TECHNICAL BULLETIN

SUBJECT: GS-207-01 Automatic Siren Disable
BULLETIN #: 0301 Rev.B
RELEASED: 09-10-02
UNIT S/N: All
MODULE S/N: N/A

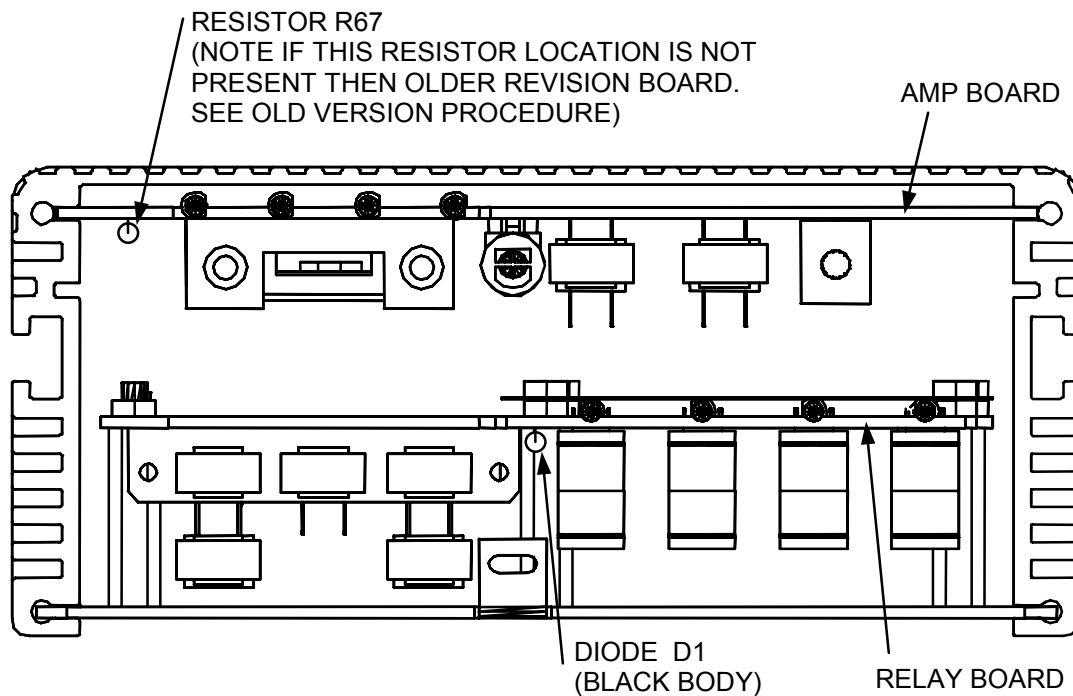
1. Remove faceplate to determine version of siren. (4 screws with 7/64" allen wrench)
If the Resistor R67 location does not exist on the AMP BOARD as shown below, use the OLD VERSION PROCEDURE.

2. On the AMP BOARD, remove R67 resistor with wire cutters.
On the RELAY BOARD remove D1 diode with wire cutters.
3. Replace faceplate. (4 screws with allen wrench)
4. Done.
